CONSTRUCTION SUMMARY				
Red Oaks on Bayview - Trinimont Developments Inc.				
PURCHASERS: JINGWEN ZHOU and YI MING ZHOU			RECEIVED MAY 25 2023	TEL:
LOT / PHASE 140 / 1	REG. PLAN # 65M-4737	HOUSE TYPE Sequoia Elev A

SEQUOIA EVEN A.

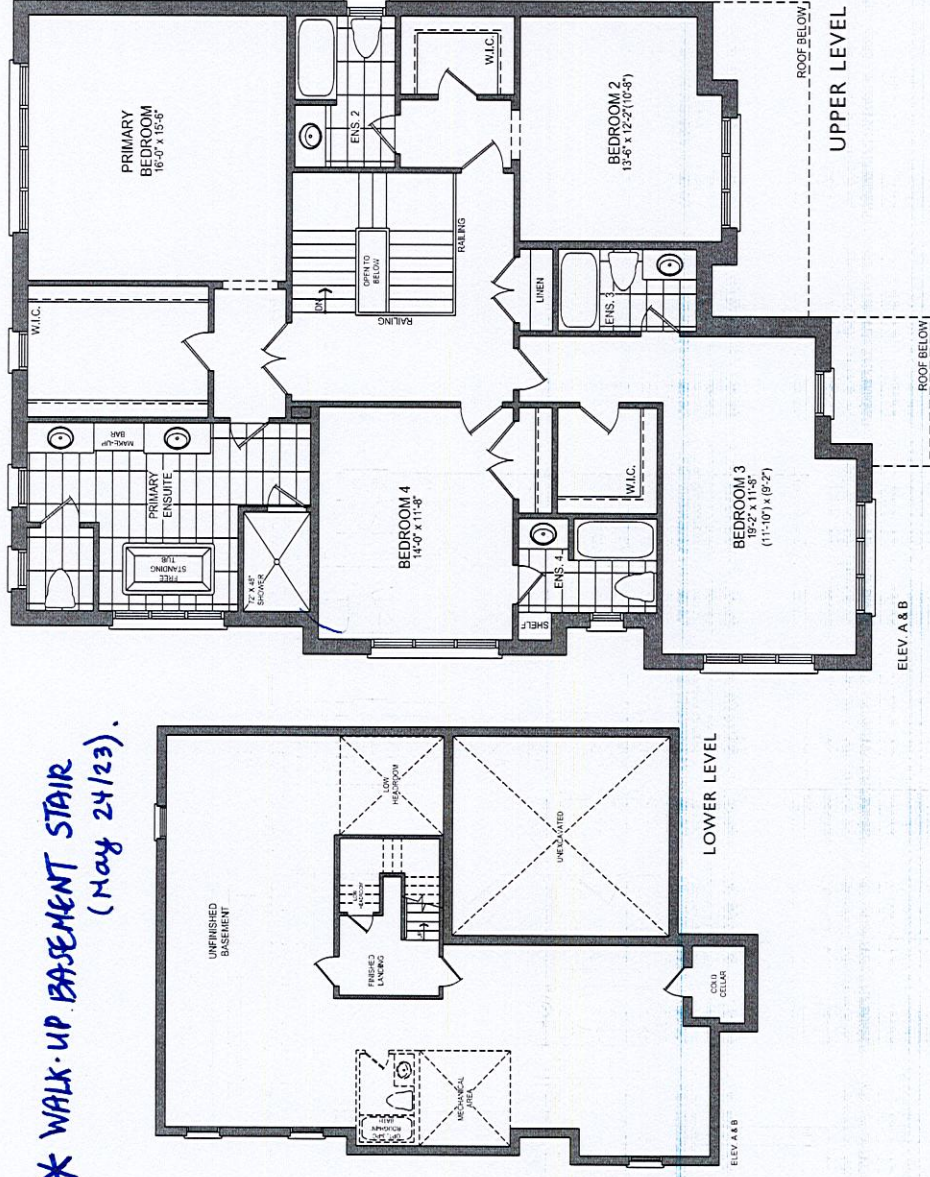
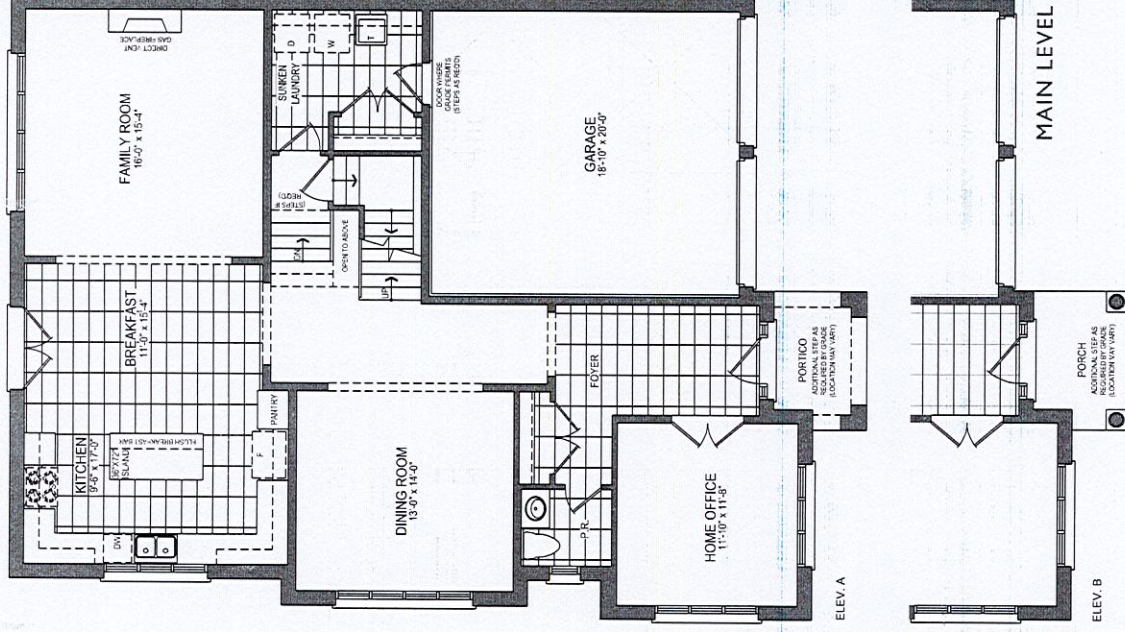
1 - PROVIDE WALK-UP BASEMENT STAIR (UNCOVERED) TO THE REAR OF THE DWELLING UNIT. 24May23 Note: If applicable, the Purchaser acknowledges and agrees that the location, dimension and configuration of the walk-up shall be determined by the Vendor in its sole and unfettered discretion. As a result of the installation of the walk-up, modifications to the main floor and basement floor plans may be required to allow for such walk-up to be installed,	
---	--

* WALK-UP BASEMENT STAIR
(May 24/23).
